URGENT – Field Safety Notice

RE: AmiCORE Apheresis Kits with possibly incorrect assembly between the saline line and the return line (ECMD202319)

(Figure 1 - Incorrect) Clear tube connected to 3rd port on the right side (orange arrow)
Blue strip line tube connected to the 4th port on the right side (red arrow)

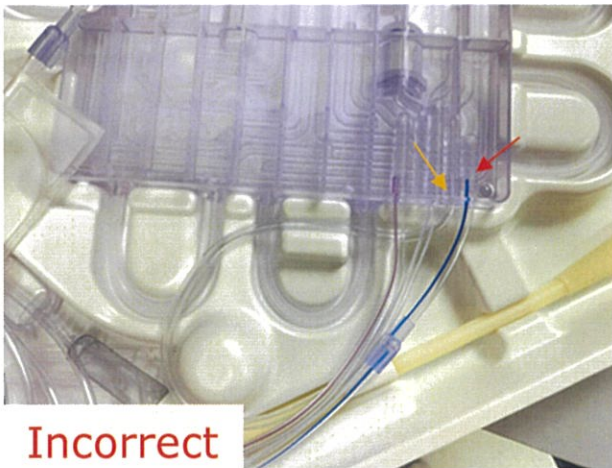
As part of our post market surveillance, it was discovered that two AmiCORE Apheresis Kits were assembled incorrectly. The saline and return lines were swapped at the connection to the AmiCORE Cassette as shown in Figure 1 and 3 below.

Incorrectly assembled saline and return lines cause the return line to not pass through the instrument's air detector. If this defect occurs and air is present in the return line, the air detector would not be triggered, and the system would pump the air into the donor's veins. This could potentially cause a serious adverse event (air embolism). Fresenius Kabi has initiated this Field Safety Notice as a precautionary measure.

When the saline line and the return line are assembled incorrectly / swapped at the connection to the AmiCORE Cassette, the AmiCORE Apheresis Kit **must not** be used (see Figure 1 and 3 below) and a new, correctly assembled AmiCORE Apheresis Kit must be used. If an AmiCORE Apheresis Kit is suspected of mis-assembly, please retain the kit and contact your local Fresenius Kabi representative for further investigation.

(Figure 2 - Correct) Clear tube connected to the 4th port on the right side (orange arrow)
Blue strip line tube connected to the 3rd port (red arrow)

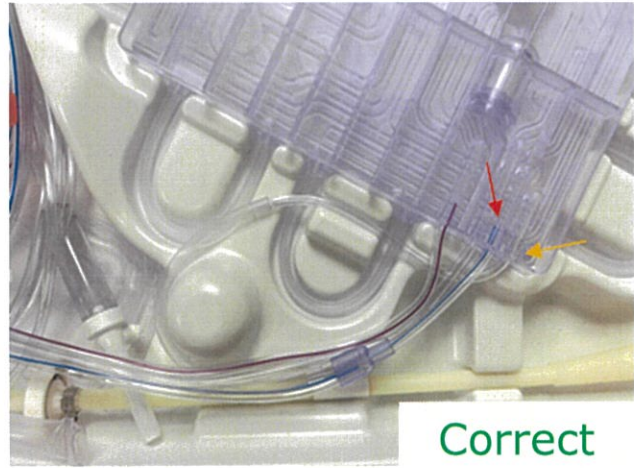
When the saline line and the return line are assembled correctly at the connection to the AmiCORE Cassette, the AmiCORE Apheresis Kit can be used in accordance with the instructions for use (see Figure 2 and 4 below).
